# CLEAN EXPRESS AUTO WASH

10 E. AUBURN ROAD, ROCHESTER HILLS, MI 48307

JNRNB2022-0013  
PSP2022-0002  
Revision #2 /  
after conditions  
review

# Site Plan Set 4-17.pdf Markup Summary

6 PAY STATION LAYOUT

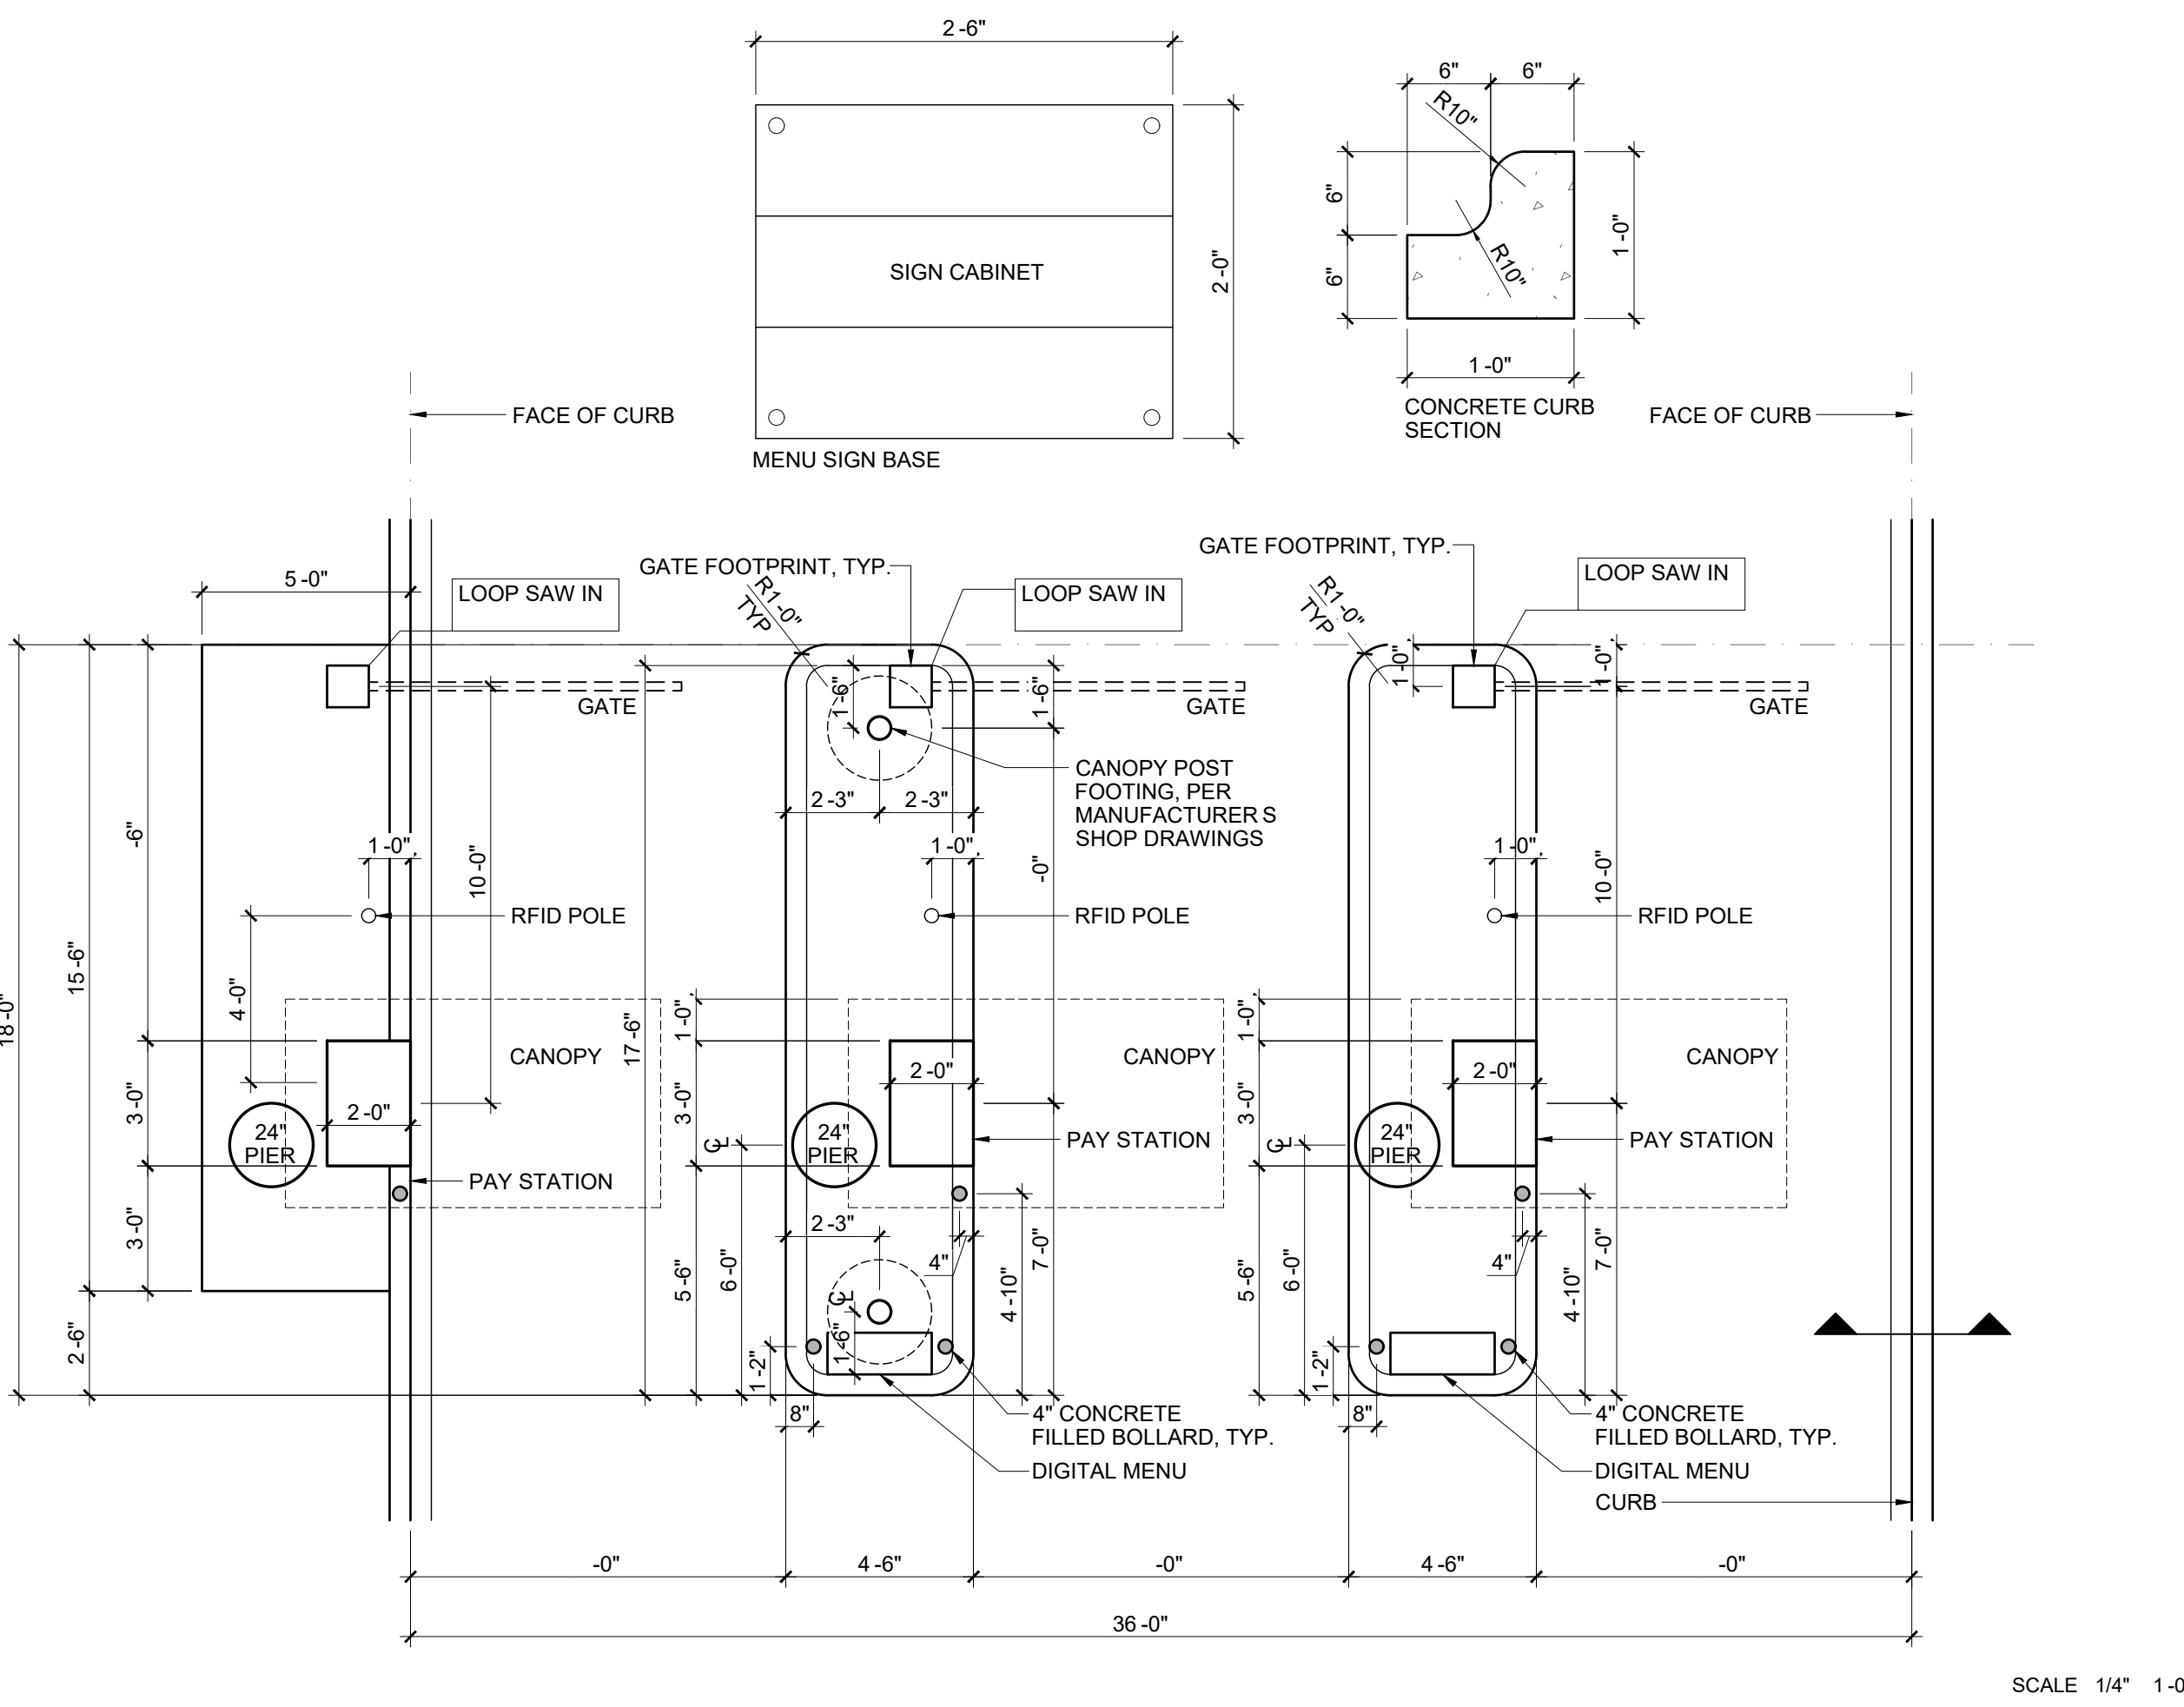
It may be appropriate to turn this sign to not

Sign location? Revised Location?
